**Landscape Review Committee**  
**Police Training Room, 121 SW Adams Street**  
**August 15, 2018**  
**12:00 PM**

**DATE:** August 15, 2018  
**TO:** McMinnville Landscape Review Committee  
**FROM:** Jamie Fleckenstein, Associate Planner  
**SUBJECT:** Agenda Item 4A: L 17-18

An application for a revised landscape plan for a new multifamily development site (L 17-18) to be reviewed by the Landscape Review Committee.

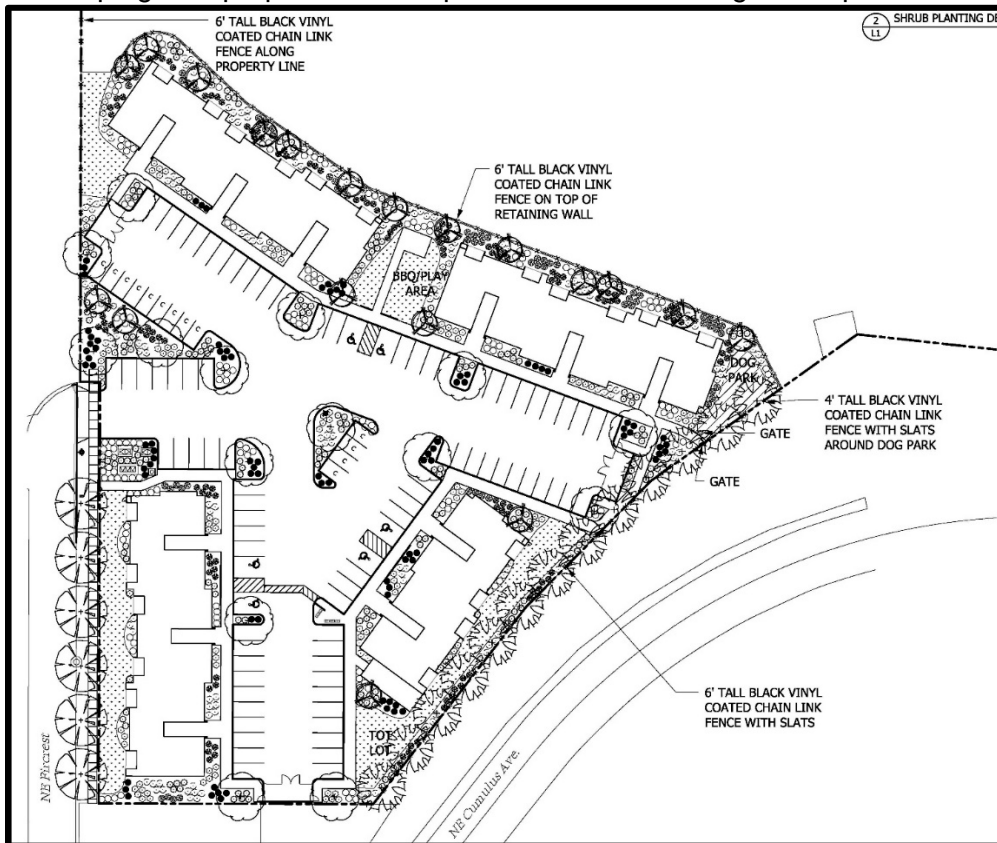
The Landscape Review Committee reviewed the application and plans at their June 20, 2018 regular meeting. At that meeting the Committee decided to continue the application to allow the applicant to make revisions to the plans to address sight-obscuring fencing along the west, south, and southeast property lines, and the addition of shade trees along the southeast property line.

Attachment 2 – Revised Landscape Plan submitted to Planning Department on July 2, 2018

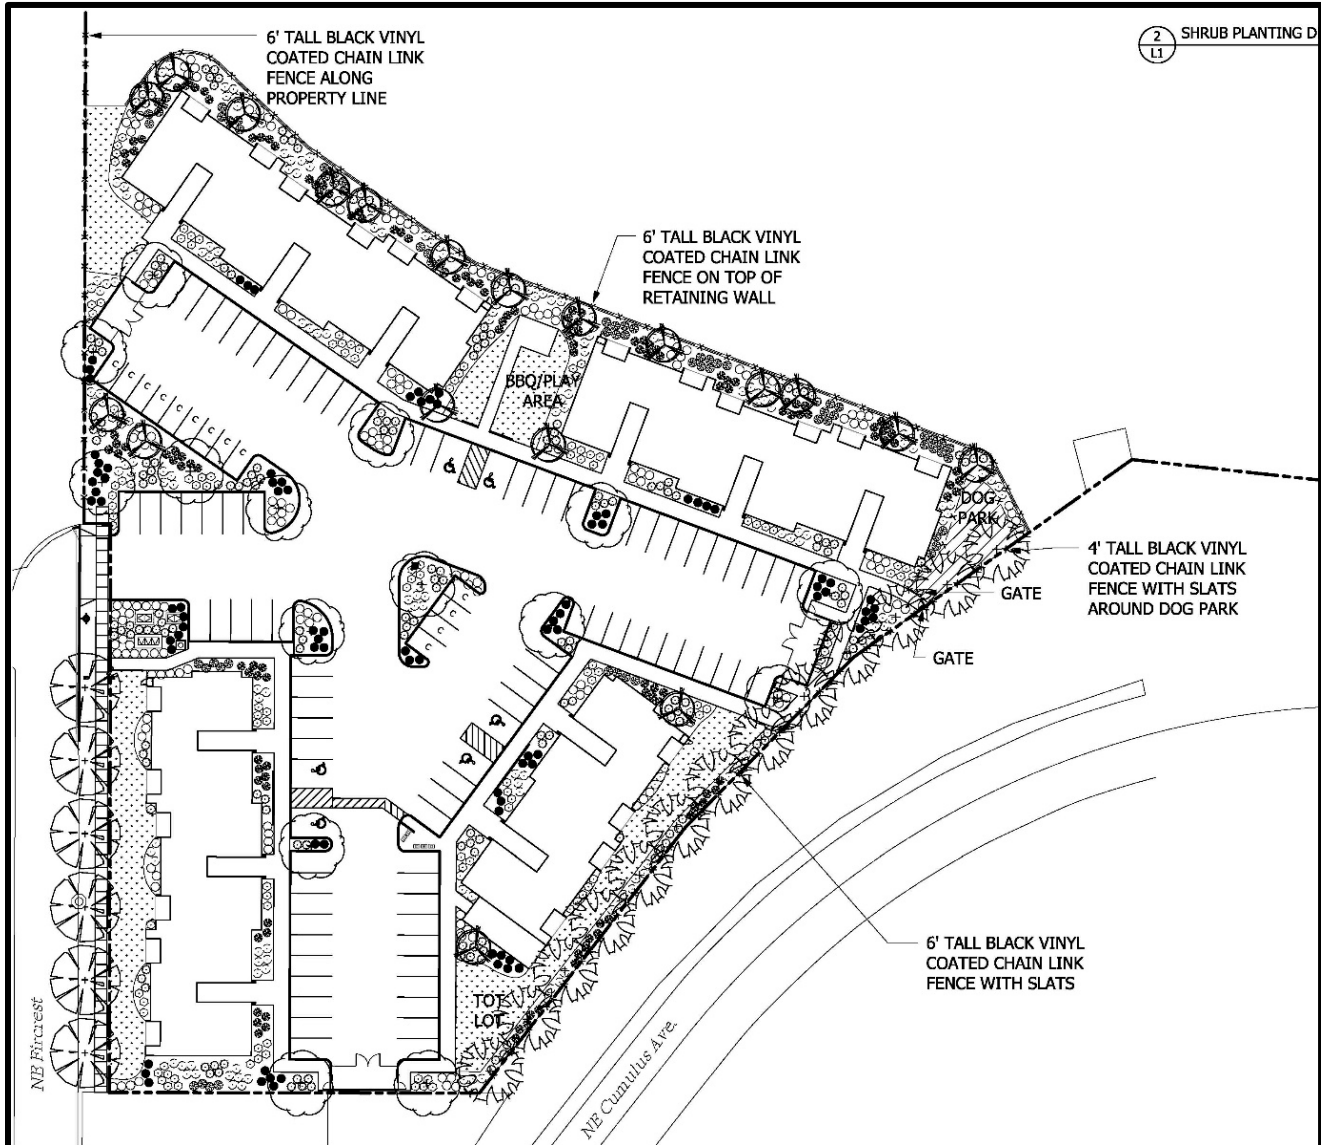
The Landscape Review Committee previously commented that the southeastern parking aisle should have a planting island adjacent to the mailboxes, to match the island on the opposite side of the drive aisle. Staff recommends a condition of approval that the parking space south of the mailboxes be converted into a planting island with a Trident Maple tree and shrub planting to be consistent with the established pattern in the other planting islands throughout the parking lot.

Additionally, an updated site plan shows the removal of the western solid waste/recycling enclosure and the addition of a parking stall replacing the planting bumpout to the north of the former solid waste/recycling enclosure. Staff recommends a condition of approval that the planting in the former bumpout be moved west, adjacent to the new parking stall to provide screening of the parking.

The plan shows the European Hornbeam trees being planted at 1.5" caliper in size. Therefore, a condition of approval is included to require that the European Hornbeam trees be a minimum of two (2) inches in caliber measured at six (6) inches above ground level at the time of installation. A condition of approval is also included to require that the street trees are planted to the City's planting detail, including staking, deep watering tubes, and root barrier protection.

11. That the parking space south of the mailboxes be converted into a planting island with a Trident Maple tree and shrub planting to be consistent with the established pattern in the other planting islands throughout the parking lot.

12. That the planting shown in the landscape area northeast of the former western solid waste/recycling enclosure, between the parking space and walkway, be moved adjacent to the newly created parking stall to provide screening.
13. That all new landscape planters and lawn areas shall have suitable watering facilities or an irrigation system.
14. That all landscaping approved by the Landscape Review Committee and required as conditions of approval shall be maintained, including necessary watering, weeding, pruning, mowing, and replacement.
